Re: Canyon Fuel Company, LLC, Sufco Mine, Permit Number C/041/0002 response to Task #4079 Northwater Mitigation Plan.

**Title:** 2012 Northwater Mitigation Plan- Second Submittal

**North Water Mitigation Plan**

Figure 1 Locations of piezometers and grout curtains in the North Water Canyon area.

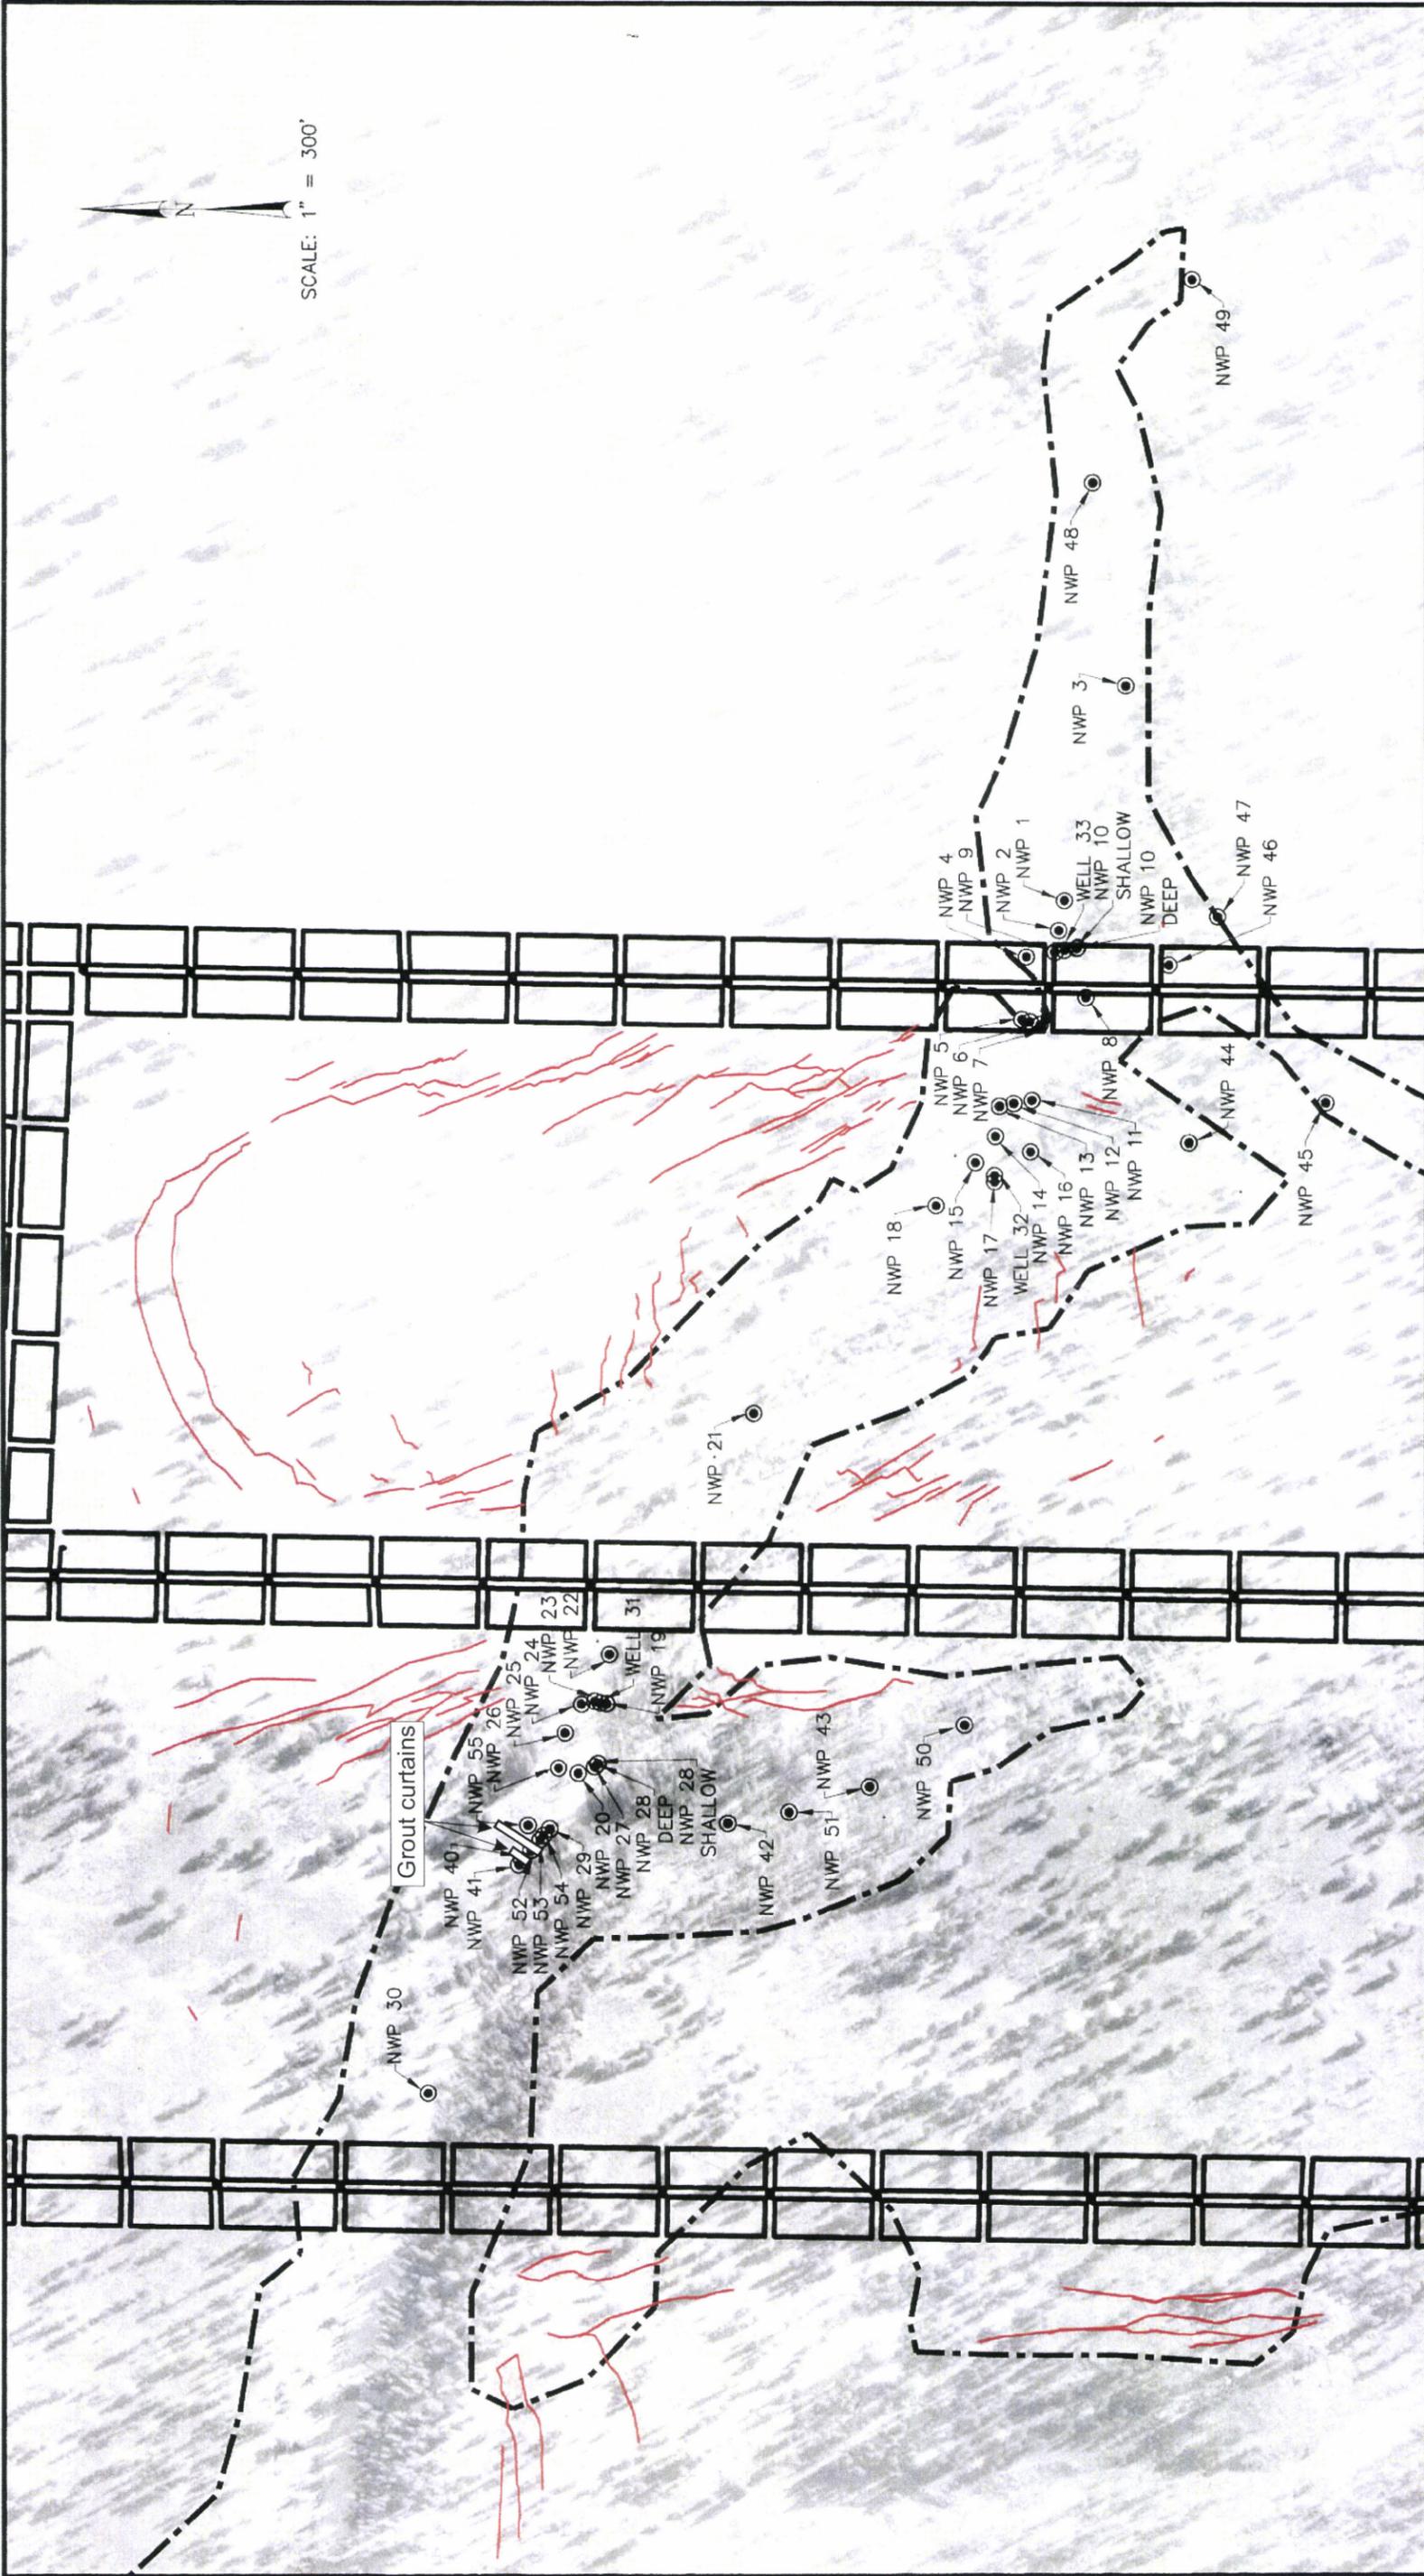
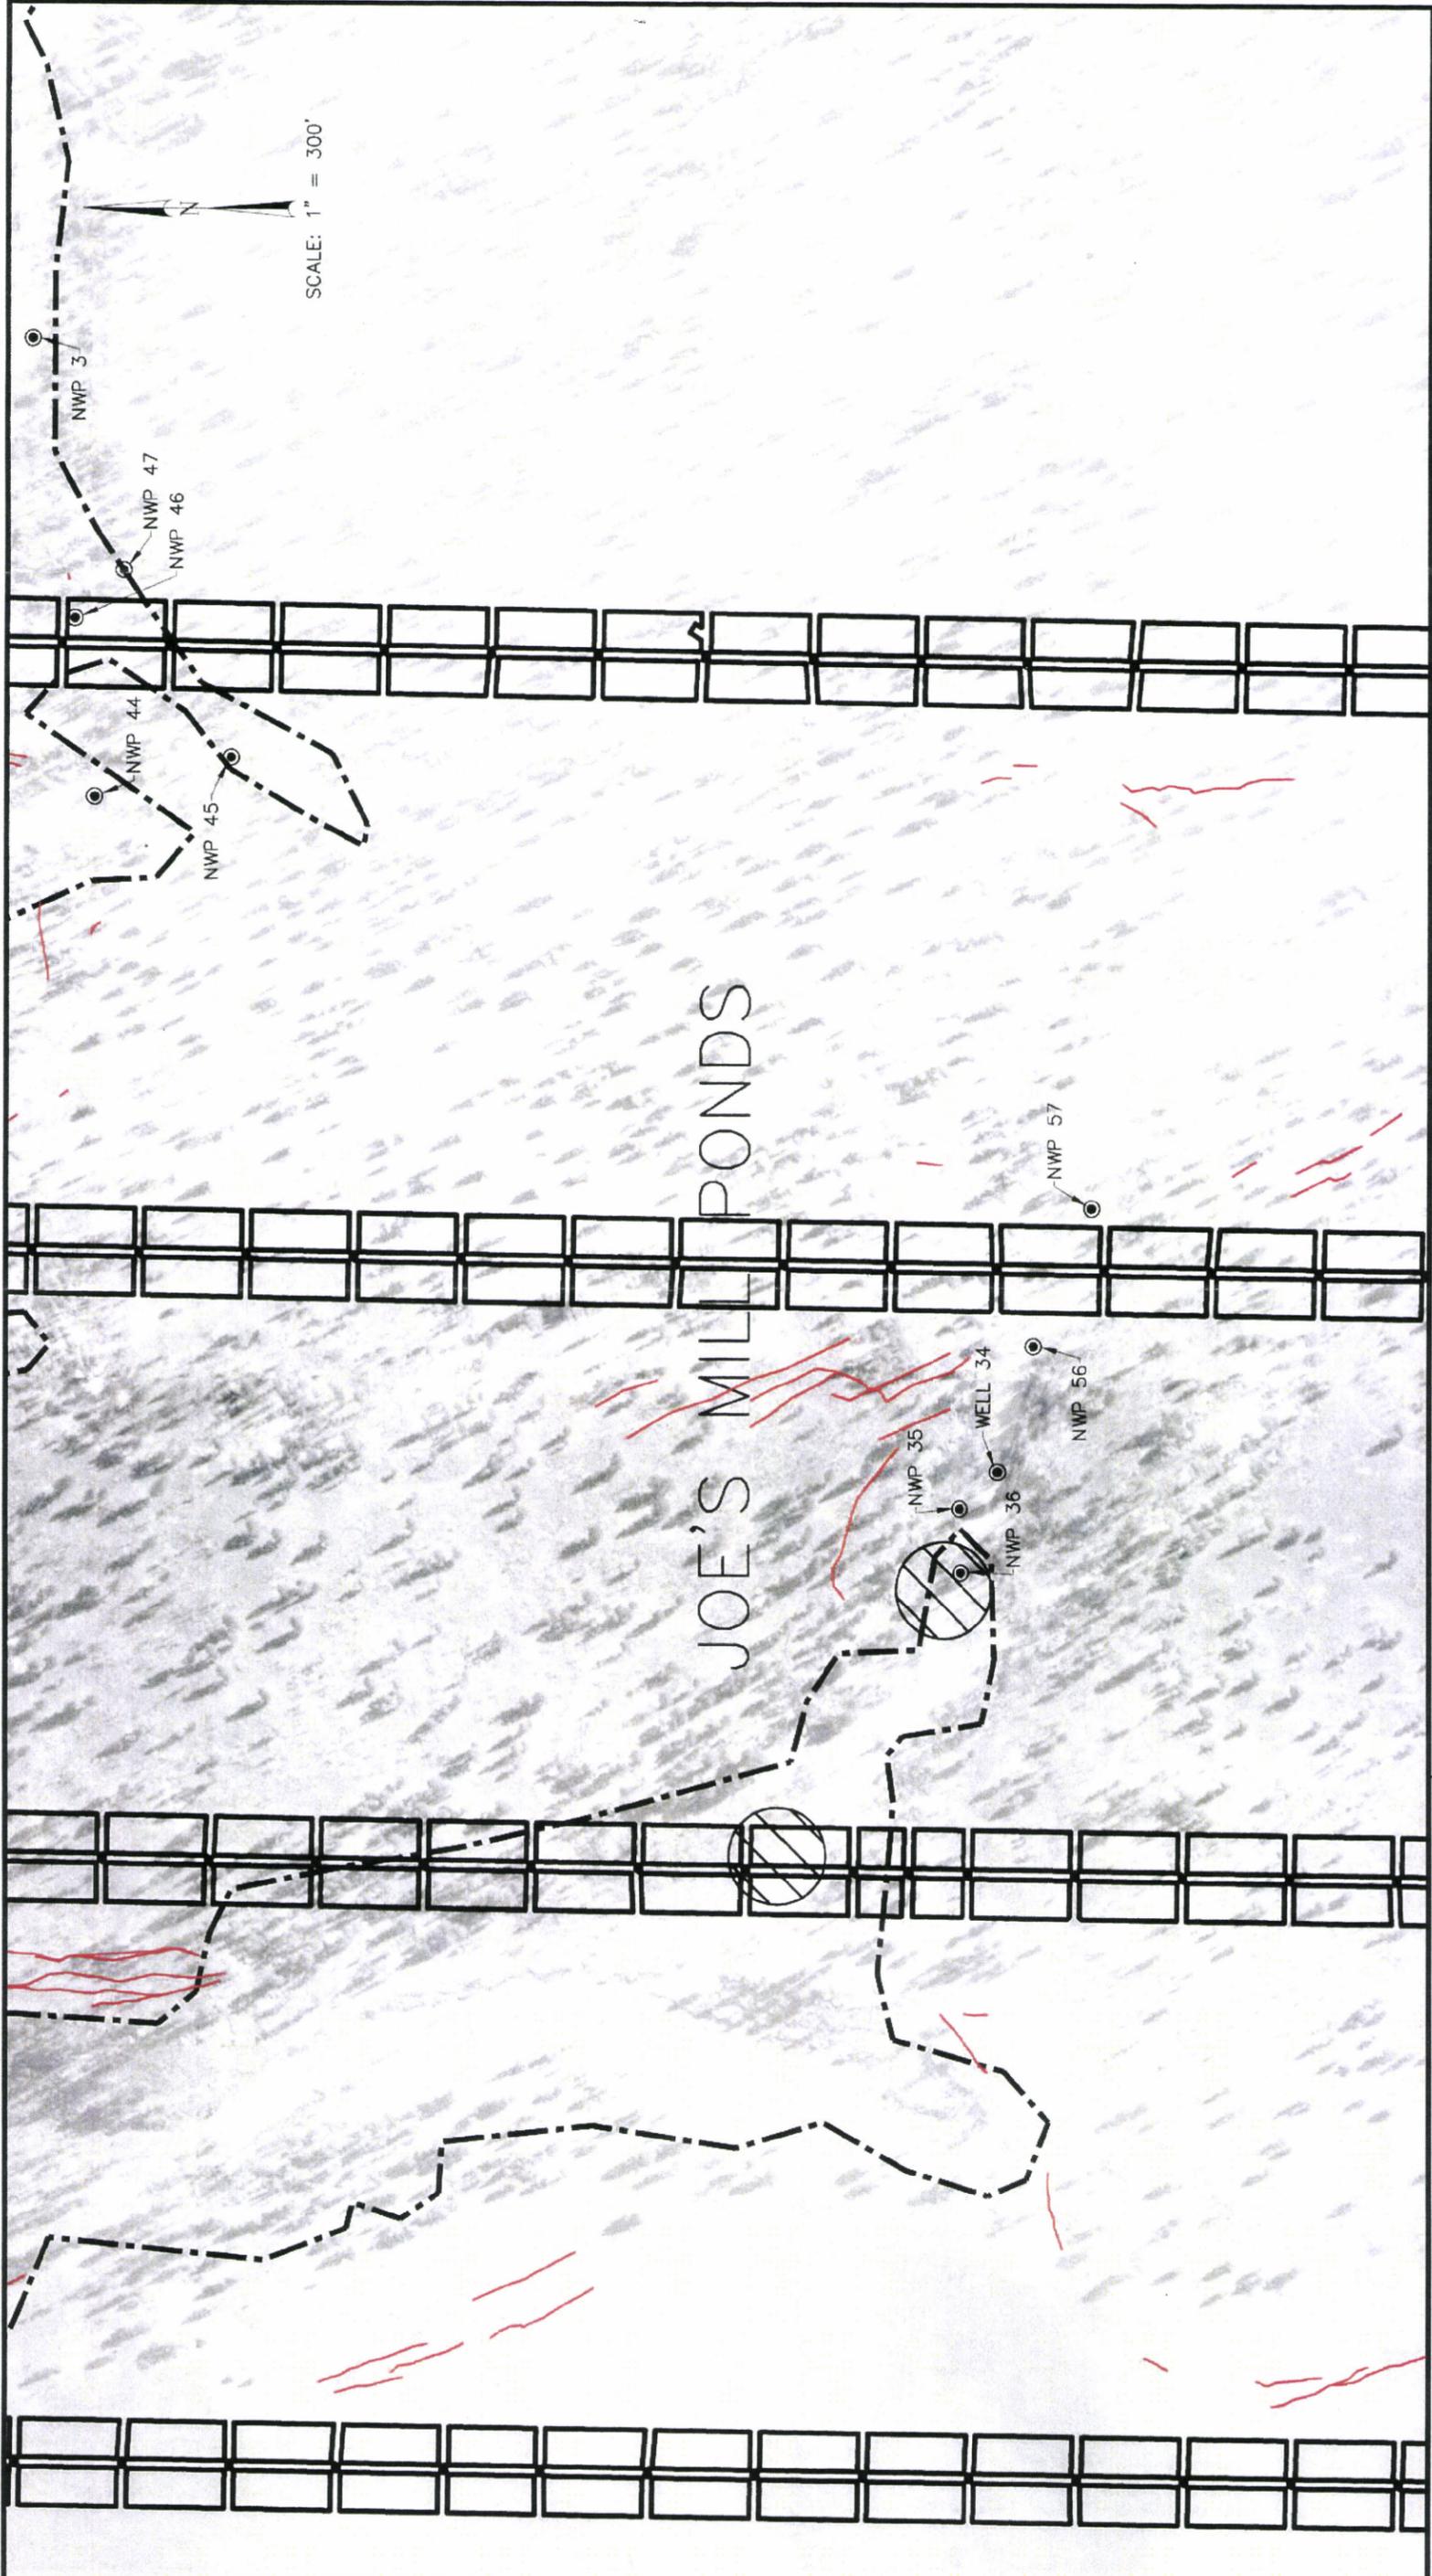
R645-301.731.750: Please include all piezometer data collected to date be included in Appendix 7-25 along with maps showing the locations of all piezometers. The Operator should add a commitment to Appendix 7-25 that piezometer data will be provided to the Division in the annual report. (AA)

*A commitment has been made in the Mitigation Plan section to provide the piezometer data to the Division in the mine's annual report.*

SHEET NO.  
**C501**

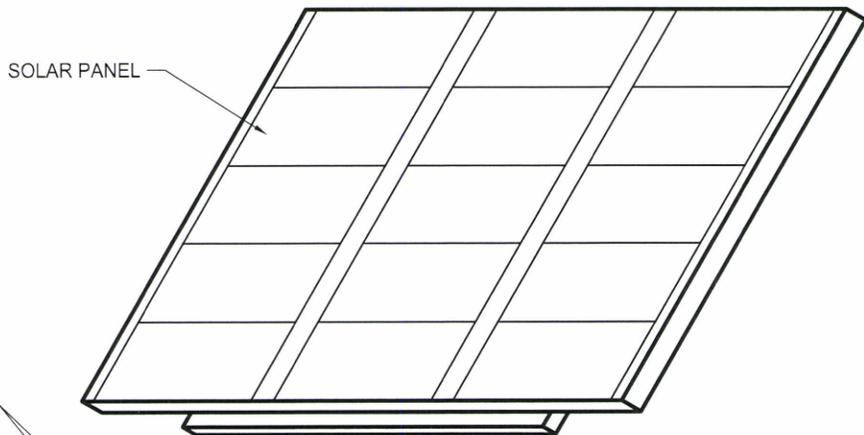
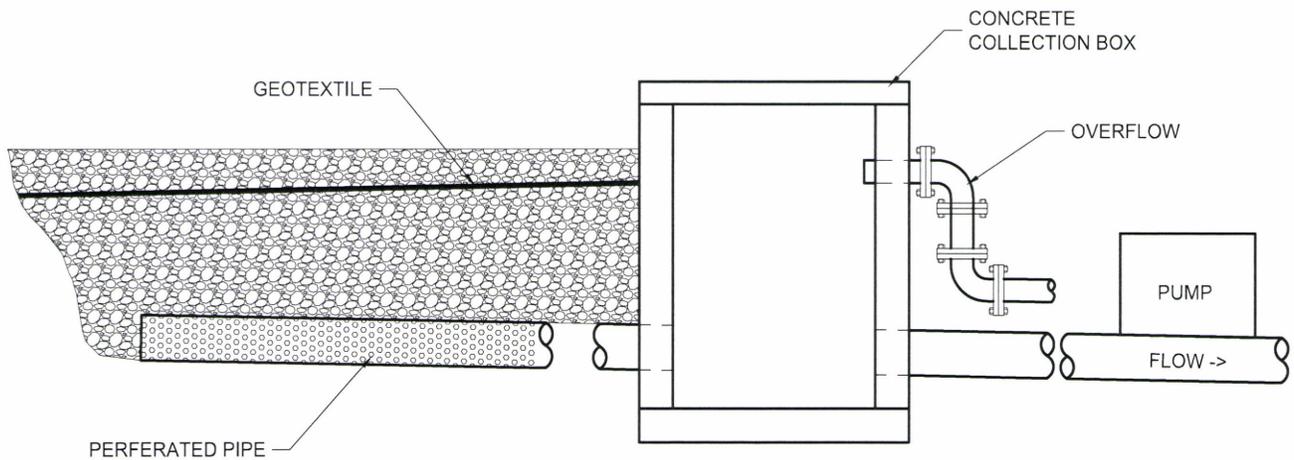
R645-301.521.180-190: The Division considers the pumping system, in its entirety, an operational support facility which will be permitted under the Sufco permit. As with other support facilities, in addition to the narrative description, the Division requires plans, design drawings, cross sections, etc. for the facility. (JO)

*Sufco has included plans and simple design drawings in this plan submittal. While the plan does include drawings of the system structures, the drawings are conceptual and the structures they depict may be somewhat different than how they are portrayed. Due to the remoteness of the project location, difficulty of access and anticipation that most of the work will be done by hand, as-built drawings that are certified will be submitted once construction is complete.*
